# Agenda

## Planning Committee

Wednesday 4 October 2023 6pm

<b>PC2310-2 .....MARINE TERRACE, NO. 96 (LOT 123), FREMANTLE – ALTERATIONS TO EXISTING HERITAGE BUILDING AND A TWO STOREY SINGLE HOUSE – (CM DA0107/23).....</b>	<b>36</b>
<b>PC2310-3 HIGH STREET, NO. 185 (STRATA LOT 1), FREMANTLE – CHANGE OF USE TO FOUR SERVICED APARTMENTS AND ALTERATIONS TO EXISTING BUILDING – (CM DA0153/23). </b>	<b>53</b>
<b>PC2310-4 JACKSON STREET, NO. 20 (LOT 1), NORTH FREMANTLE – ADDITIONS AND ALTERATIONS TO EXISTING SINGLE HOUSE – (JD DA0199/23) .....</b>	<b>61</b>
<b>PC2310-5 MANNING STREET, NO. 5 (LOT 28) FREMANTLE – VARIATION TO DA0100/22 (TWO STOREY ADDITIONS AND ALTERATIONS TO EXISTING SINGLE HOUSE) (ED VA0012/23) .....</b>	<b>68</b>
<b>PC2310-6 .....SOLOMON STREET NO. 83 (LOT 62), FREMANTLE – TWO STOREY SINGLE HOUSE WITH BASEMENT – (CM DA0160/23) .....</b>	<b>86</b>

**Figure 3 - Earthworks plan marked up to show POS that is either road verge or Pedestrian Access Way**

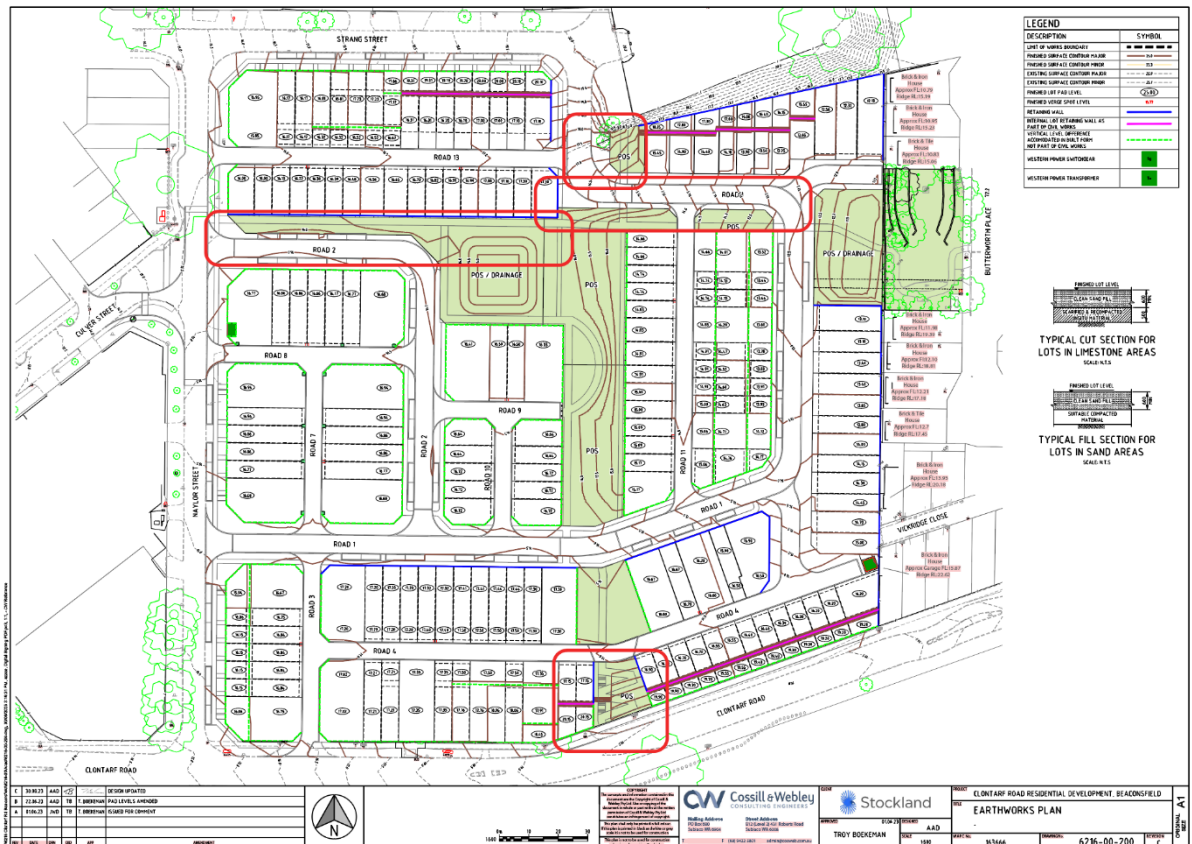
- Some of the spaces that have been designated Public Open Space on the sub-division plan would be more accurately described as street verges and whilst contributing welcome greenery to the street environments should not qualify as contributing to the Public Open Space component of the sub-division.

- The proposed connection to Clontarf Road is a requirement for accessibility and also should not be included in the Public Open Space calculation as it is largely consumed with ramps for access due to a 3m level change.

- The POS performing a drainage function adjacent to the neighbouring Butterworth Place open space contributes to a larger area of POS connecting the two residential subdivisions, but it will also require a holistic redesign to join the two parcels for recreational functionality due to level changes. In addition, the pedestrian path coming through from Butterworth Place into the east-west linkage through the development needs to be of a larger dual use nature to accommodate both cyclists and pedestrians. This link into Butterworth Place is currently the only opportunity to link into the sub-regional open space linkage to the north.

Figure 2 – Southern Elevation showing boundary wall (green – abuts simultaneous boundary wall; red – abuts adjoining property’s outdoor living area; blue abuts common property access way and carport)

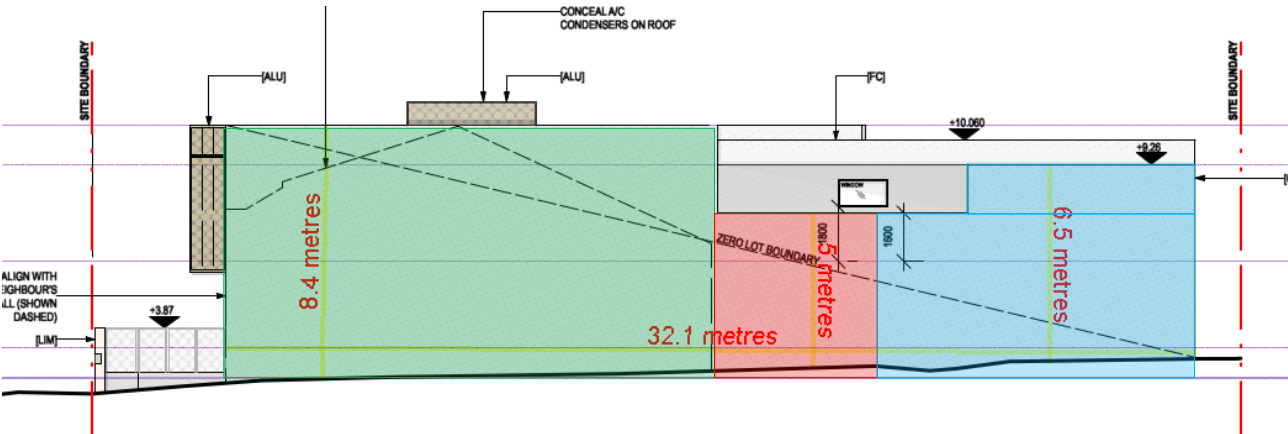
The application seeks approval for a 32.1metre long boundary wall with a height of 8.4m toward the front of the dwelling, before stepping down to 5m in height and then back up to 6.4m toward the rear of the dwelling. Figure 2 below shows the boundary wall on the southern elevation, with the green sections indicating where it abuts a simultaneous boundary wall, the red section indicating where it abuts the adjoining properties outdoor living area, and the blue indicating where it abuts the adjoining sites common property and carport. Figure 3 shows an image of the existing boundary walls located at 98 Marine Terrace for context.

- Whilst it is noted that the majority of the boundary walls as highlighted in green on the Figure 1 abut a simultaneous boundary wall on the adjoining property to the south, the red portion abuts the adjoining property's outdoor living area and does not allow for adequate direct sun and ventilation onto the outdoor living area and open spaces. Figure 4 below shows that the entire outdoor living area of No. 98 Marine Terrace is overshadowed.
- The full length of the boundary wall does not reduce the building bulk on the adjoining property to the south as its primary outdoor living area is directly impacted by the boundary wall.

**Figure 4** – Current Overshadowing diagram (2<sup>nd</sup> Set Amended Plans)

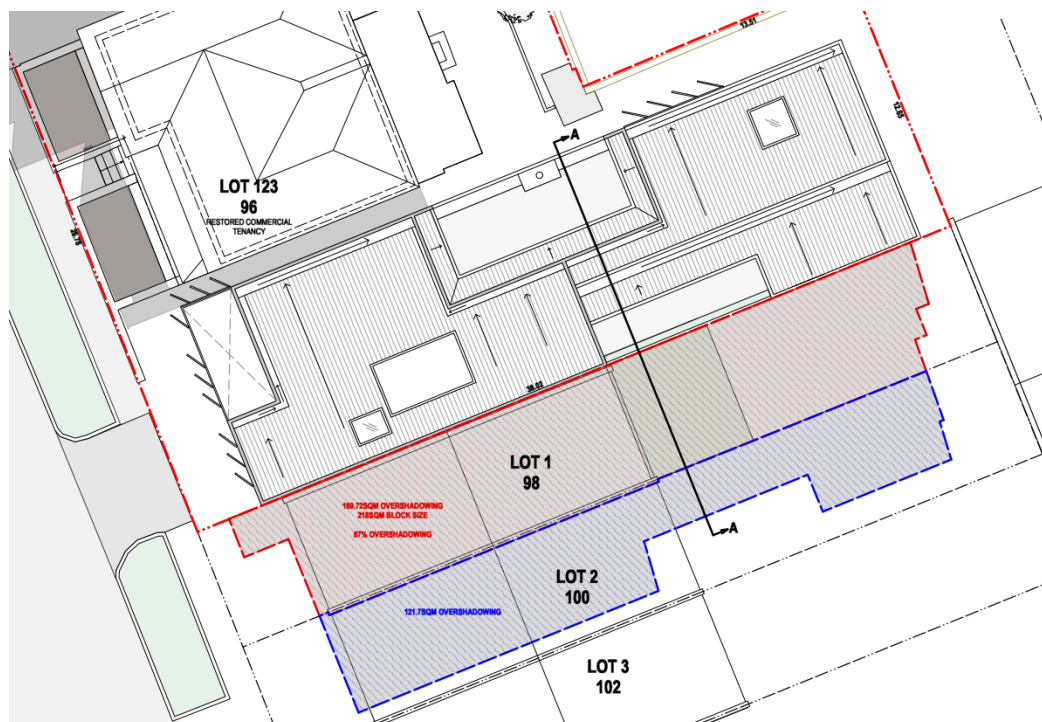
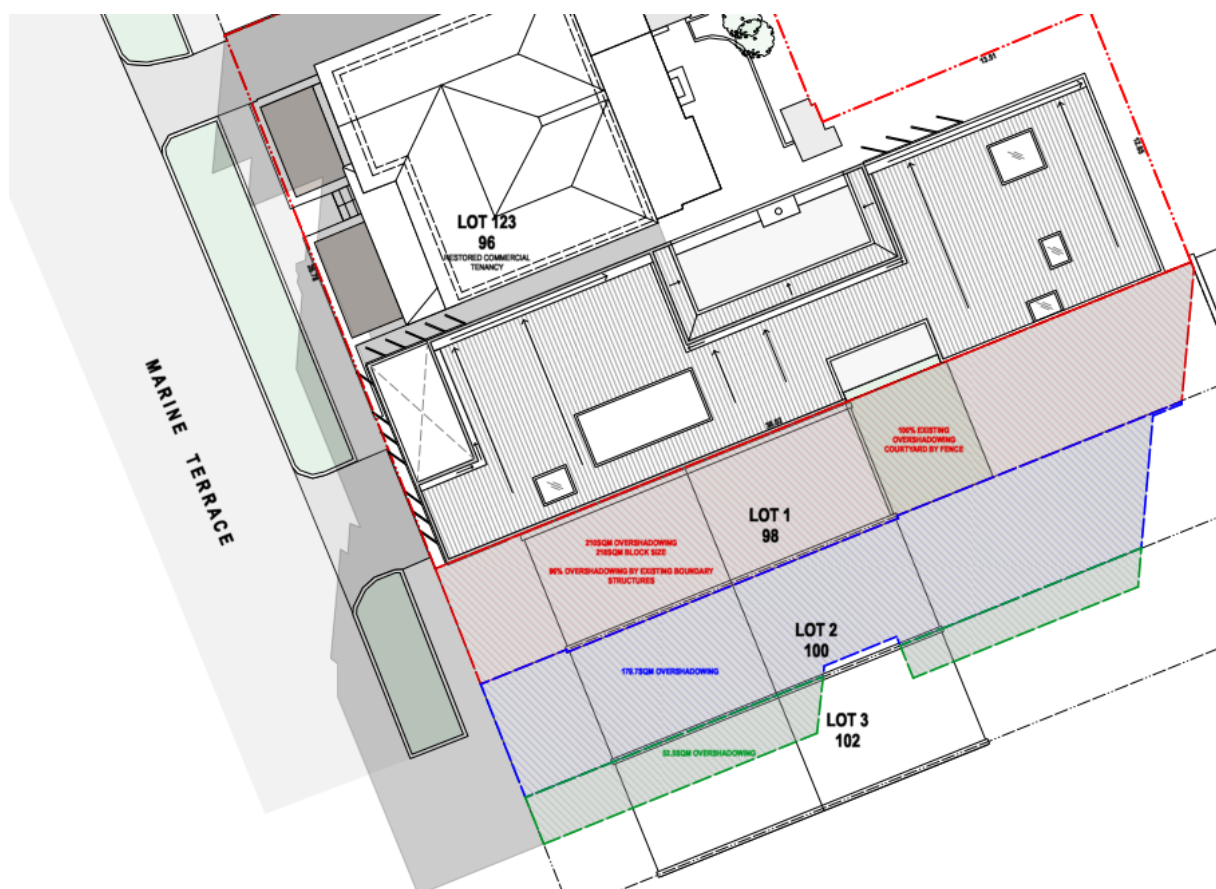
- The development has not been designed to protect solar access for adjoining properties in respect to outdoor living areas, noting that the entire outdoor living area on the southern adjoining property at 98 Marine Terrace is overshadowed, and a large portion of the outdoor living area further south at 100 Marine Terrace is also overshadowed. Figure 4 below shows the extent of the overshadowing onto the two adjoining properties to the south.

It is acknowledged that the applicant has reduced the overshadowing as compared with the plans originally submitted, which can be seen in figure 4 and 5 below. The original plans submitted with the application indicated the building would overshadow 100% of the outdoor living areas of adjoining lots 98 and 100 Marine Terrace and only a portion of 102 Marine Terrace, whilst the amended plans overshadow 100% of the outdoor living area of 98 Marine Terrace and only a portion of 100 Marine Terrace, and leave 102 Marine Terrace without any impacts of overshadowing.

**Figure 6** – Cross section showing the angle of the overshadowing will not impact on the roof space of adjoining property at 98 Marine Terrace.

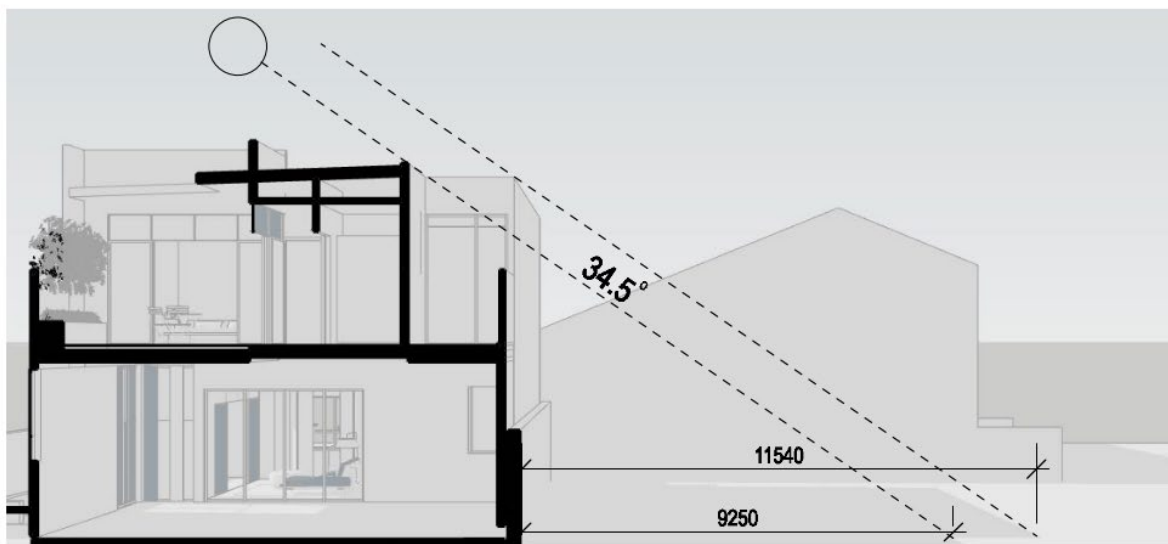
- The development has been designed to protect solar access for neighbouring properties in respect to roof mounted solar collectors, or in this instance, the ability to provide for roof mounted solar collectors. The applicant in its amended plans (attachment 1) has modified the roof line so that the angle of the sun will not impact on the roof of the adjoining building. Figure 6 below shows the angle of the sun which does not impact the adjoining properties roof.

To summarise the above assessments with respect to overshadowing, whilst the angle of the overshadowing will not impede on the roof space of the adjoining properties, the shadow will cover the full extent of the adjoining properties outdoor living area to the south, and a large part of the property further south than that. While there is a small courtyard and balcony on the front of the southern dwelling, the central courtyard is outside the primary street setback and is a more private space for residents. It is acknowledged that the lot to the south is small, however given the large boundary walls on these dwellings, there are extensive amounts of the lot boundary that provide opportunities for this development to throw shadow with reduced amenity on the occupants.

**Figure 8** – Existing primary street fencing (left) and proposed (right)

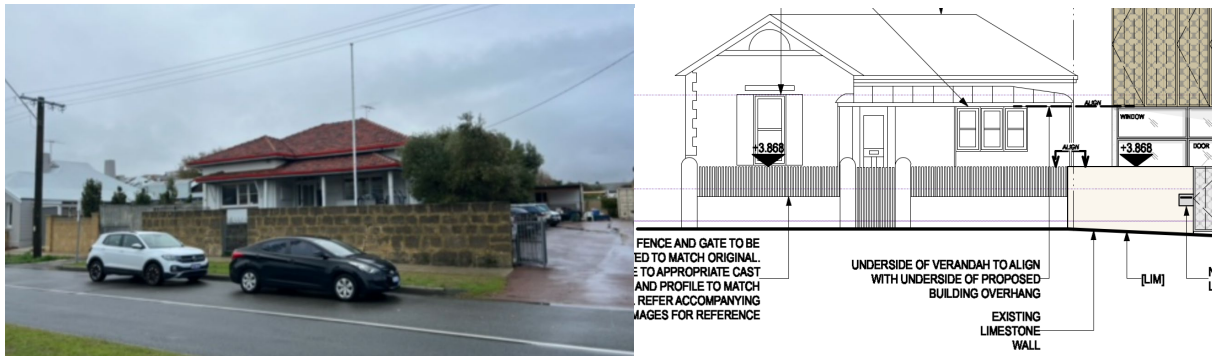
The proposal seeks to replace the existing solid fencing in front of the heritage dwelling with a new fence which varieties the deemed to comply requirements as set out in LPP2.8 – Fences. A portion of the existing fence (as shown in figure 8 below) is proposed to be retained in front of the proposed new dwelling.

The proposed front fence is considered to meet the Design principles of the R-Codes in the following ways:

**Figure 1** – Location of driveway on eastern side of lot.

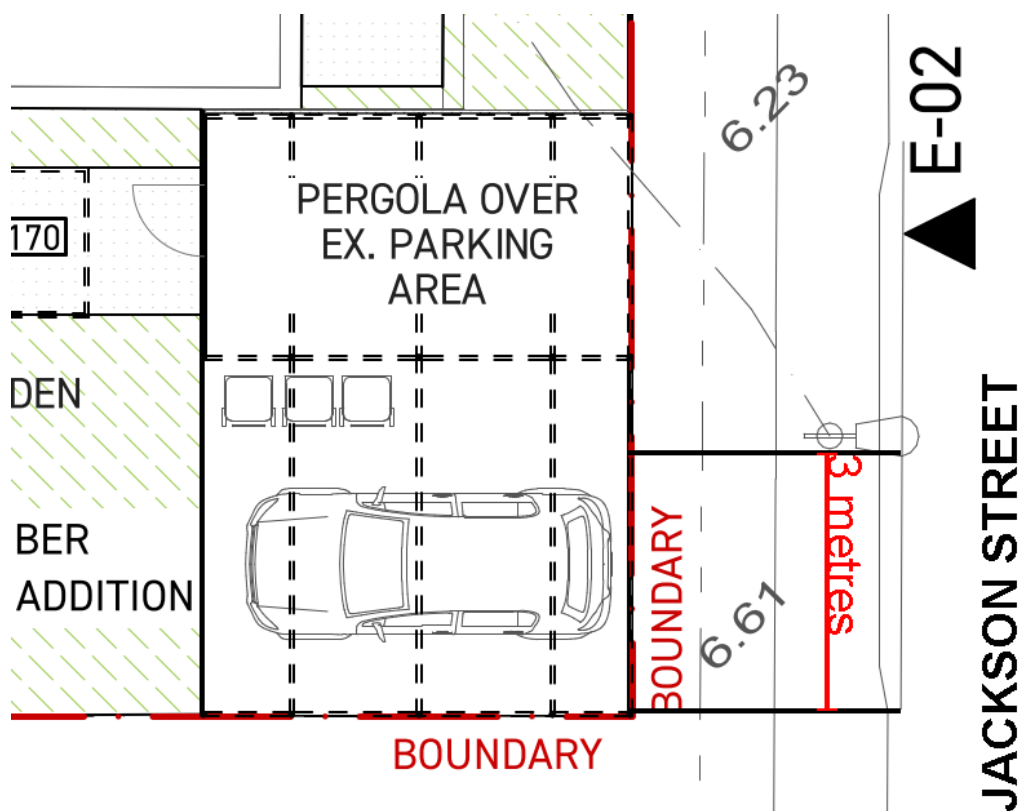
- As illustrated in Figure 1 below, the minimum driveway width supported under LPP2.9 at the street boundary is 3m. This results in a separation from the side boundary and the street pole of 50mm. This is considered to be an insufficient separation and will not allow for vehicles to safely enter and exit the site.

- The existing mountable kerbing on the road edge is considered redundant as it is not servicing any existing driveway/parking space (i.e., the existence of a mountable kerb is not taken to be approval for vehicular access). Regardless of the existence of this mountable kerb, it would require further modification to provide vehicular access to the proposed parking space on the east boundary which would not be supported by the City's Engineering and Infrastructure services.

- The area to the west of the street pole is currently being used for parking and is considered to be the appropriate location to provide the one (1) parking space required under the R-Codes (the subject site is located within 250m of a high frequency bus route).

**Figure 2** – Building height in relation to the site's topography.

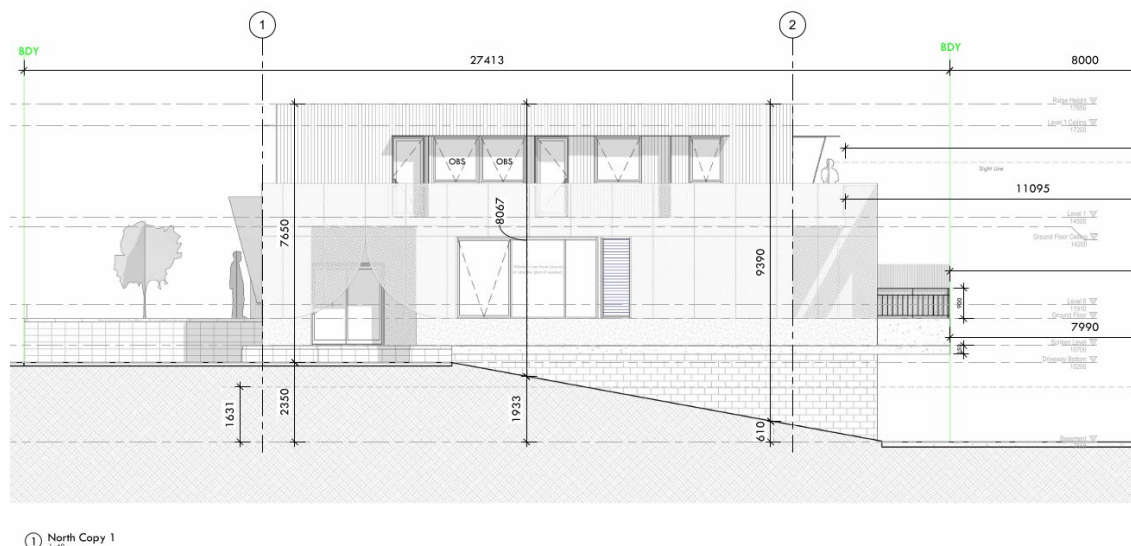
- The building height will not have an adverse impact on the amenity of the adjoining properties or the streetscape. It is noted that the wall height complies toward the front of the property as viewed from Solomon Street, and exceeds the 8.0 metre deemed to comply requirement toward the rear of the site where the sites topography drops. Figure 2 below shows the building in relation to the existing natural ground level. It is also noted that the building is stepped in from the rear to reduce the building bulk impact on the property to the west.

- The building height allows for adequate access to direct sun into buildings and open spaces on adjoining lots, noting that any overshadowing that will occur from the building will only impact the vacant portion of the site to the south. It

**Figure 5** – Cone of vision from ground floor balcony to the rear

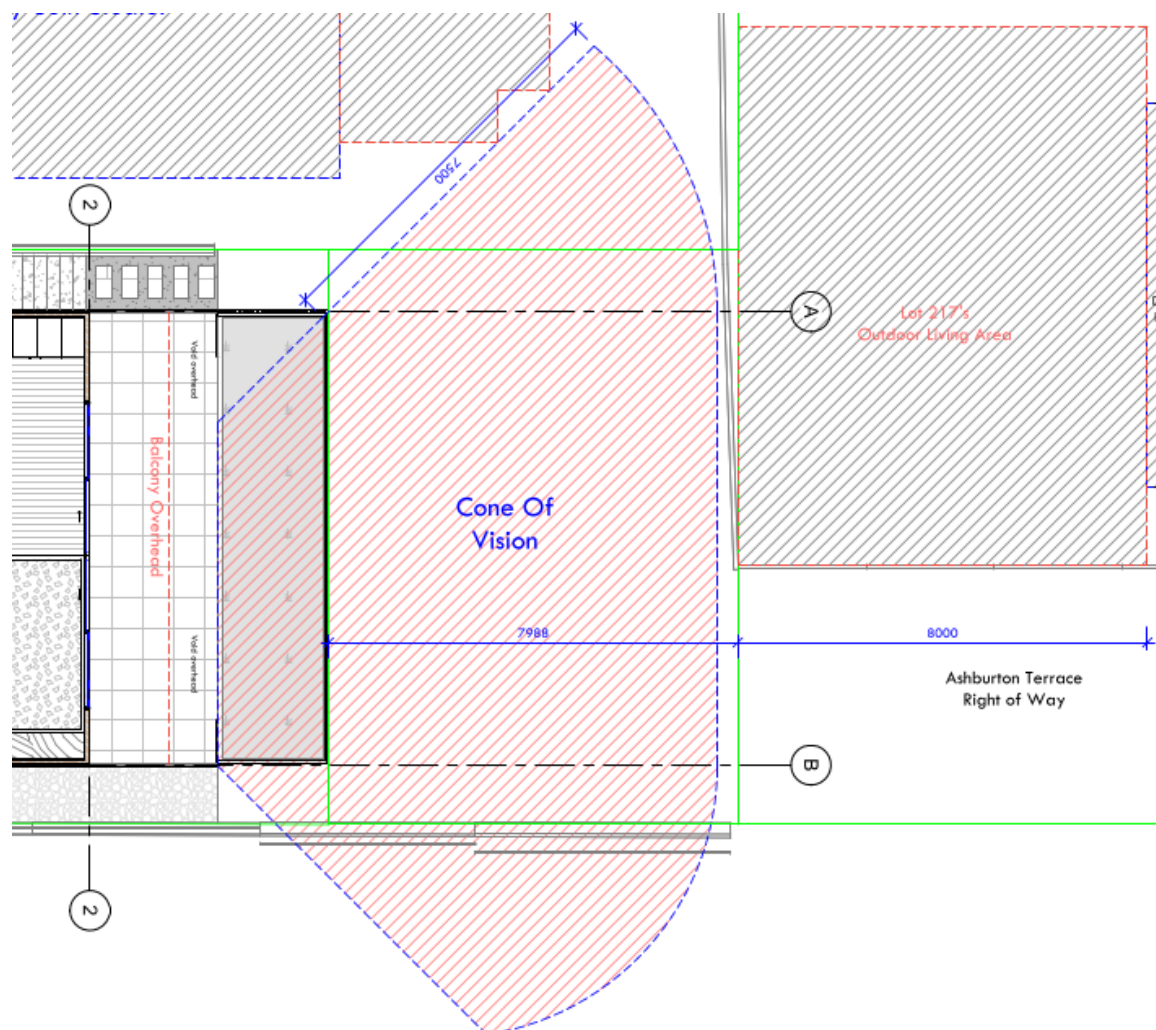
Noting that the property seeks a building height discretion and proposes a balcony on the ground and first floor looking to the west, cone of vision to the western property complies with the deemed-to-comply requirements of the R-Codes. Figure 5 below shows the cone of vision in relation to the adjoining property to the west (2A Ashburton Terrace). Whilst it is not a requirement, the applicant has implemented some screening devices on the first-floor balcony and provided a description of this at attachment 2.

**Figure 3** – Proposed retaining in front setback area (in yellow) as viewed from Solomon Street

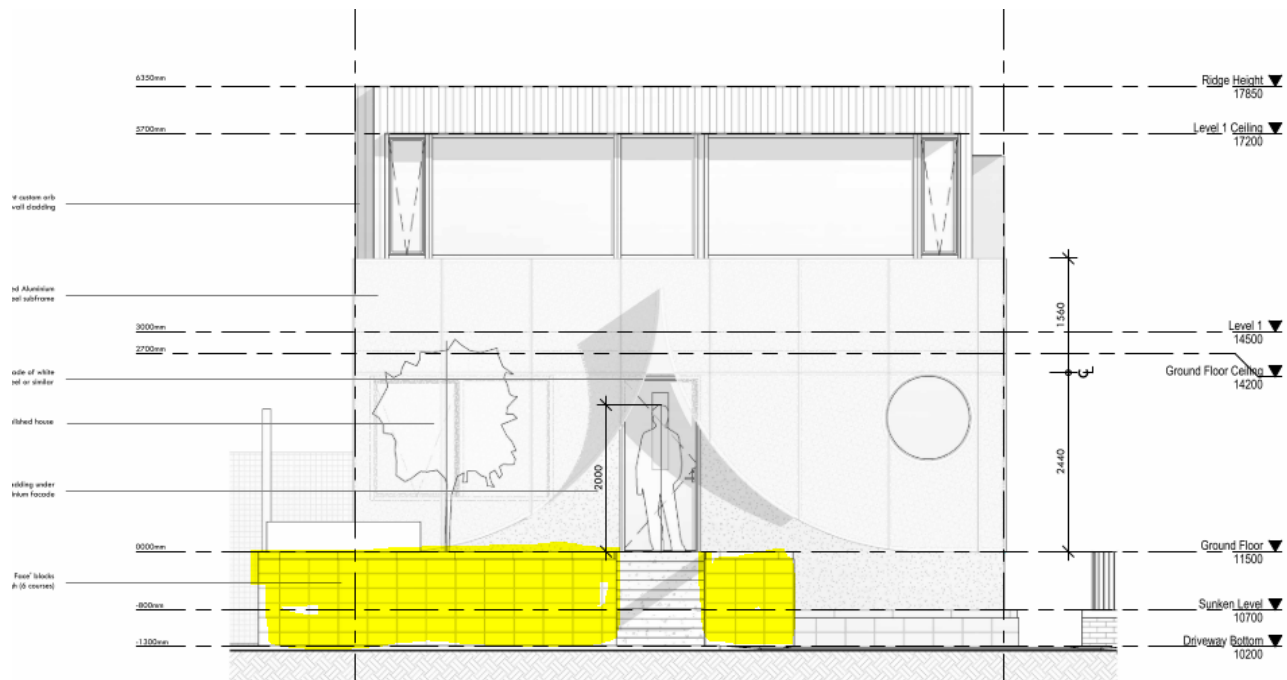
The proposal seeks to retain and fill within the primary street setback area to accommodate for a raised garden bed which is consistent with the height of the front door of the dwelling (FFL 11.500). Figure 3 below shows the retaining as viewed from Solomon Street for context.

The proposed site works are considered to meet the Design principles of the R-Codes in the following ways:

**Figure 2** – Height and location of proposed boundary wall.

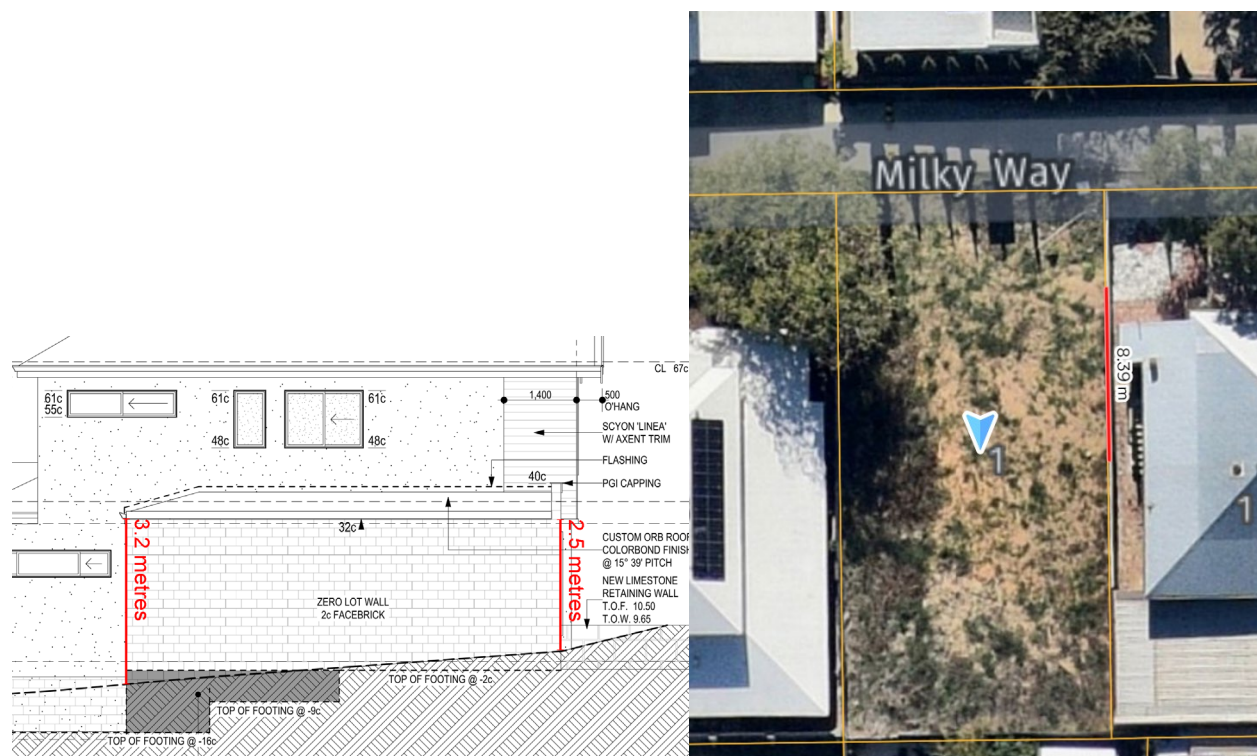
- The boundary wall is setback 4.67m from Milky Way which is considered sufficient to maintain sightlines.
